Eagle Mountain Pumped Storage Project – Landfill Compatibility

Prepared by: Richard Westmore, P.E., GEI Consultants, Inc. and Ginger Gillin, GEI Consultants, Inc.

April 8, 2009, revised November 24, 2009 and August 13, 2012

January 2011 update: Response to Additional Comments from Kaiser and Others in Review of the July 2010 Draft Environmental Impact Report.

OVERLAY OF LANDFILL PROJECT (1997 UPDATE) AND PUMPED STORAGE PROJECT (DEIS)
June 2011
Figure 4, Sheet 4 of 4

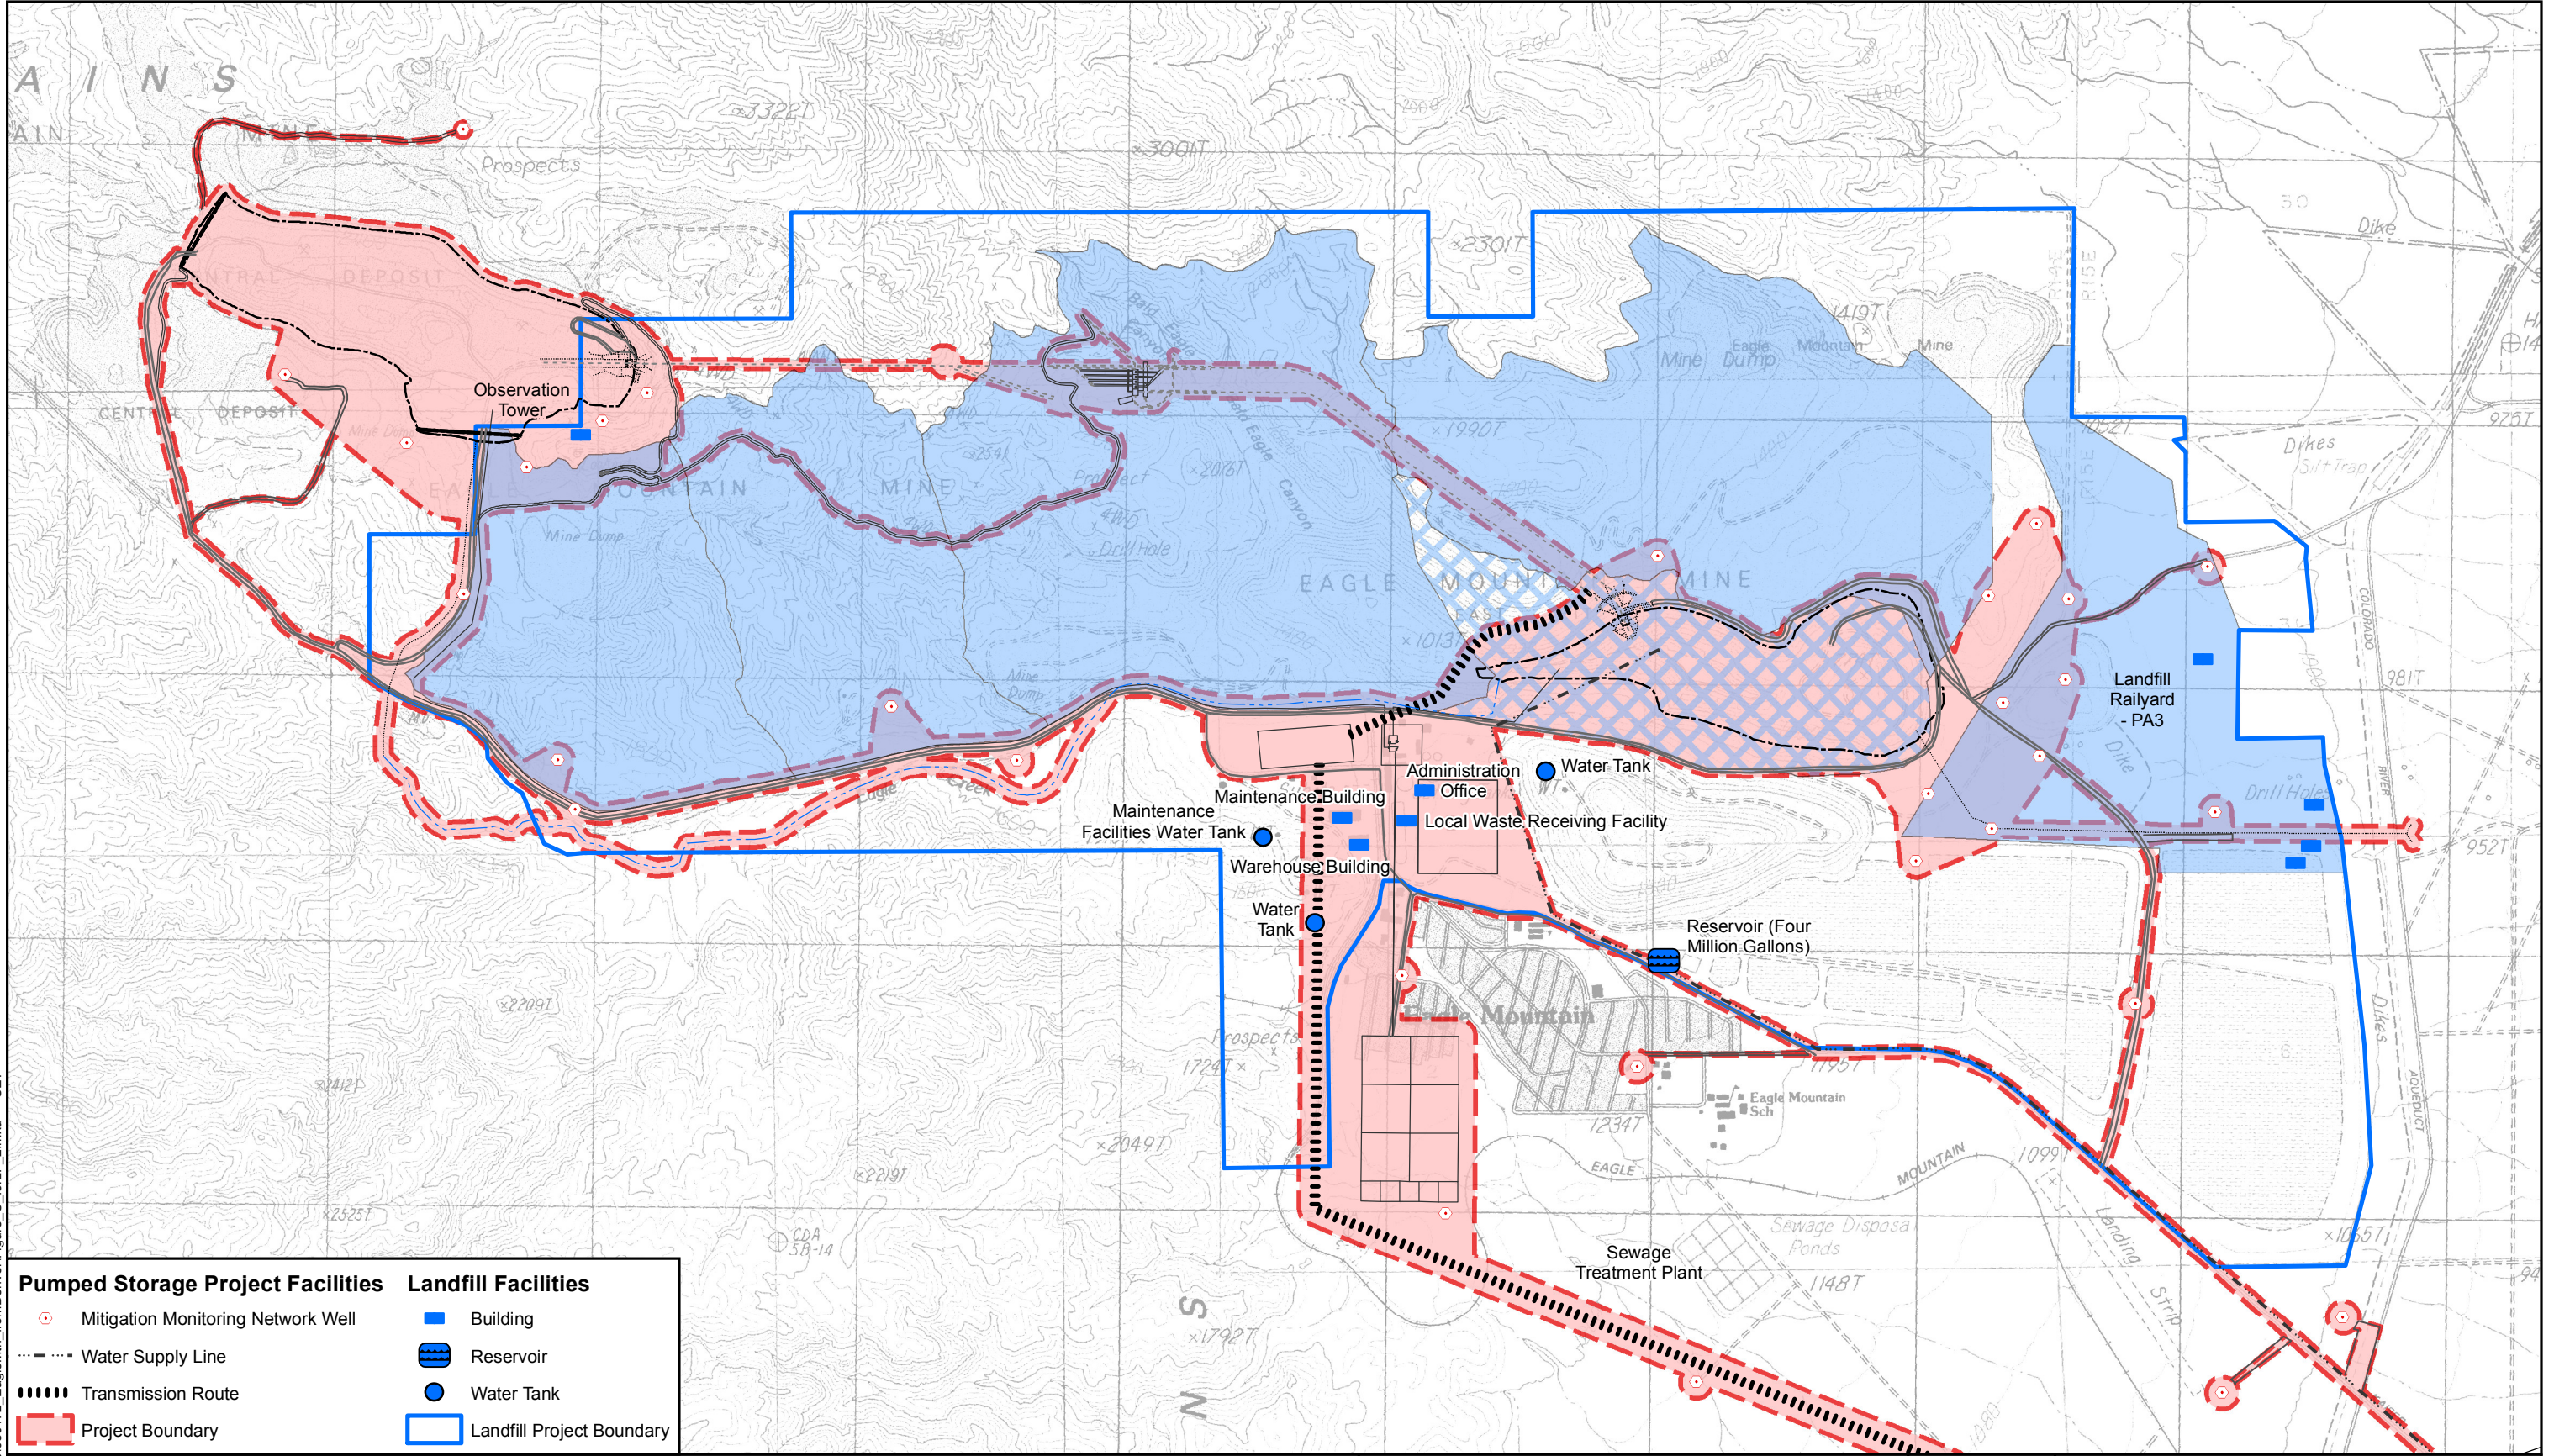
Kaiser concern: Certain proposed Project facilities could interfere with the planned Landfill rail yard and RO/Admin facilities for the Project.

Response: ECE developed Figure 4 using the most-current landfill design drawings which are publically available (dated October 1997). Based on this project layout, ECE understands that the railyard and operations center would be located on the east side of the Landfill. However, other, older drawings from the proposed Specific Plan show the railyard to be located south of the East Pit for the early years of landfill development. The ideal location for the proposed Project switchyard and RO facilities and structures is the one currently shown on the Project drawings. Therefore, it appears that further discussions between ECE and landfill interests will be required as final planning and design of both projects proceeds.
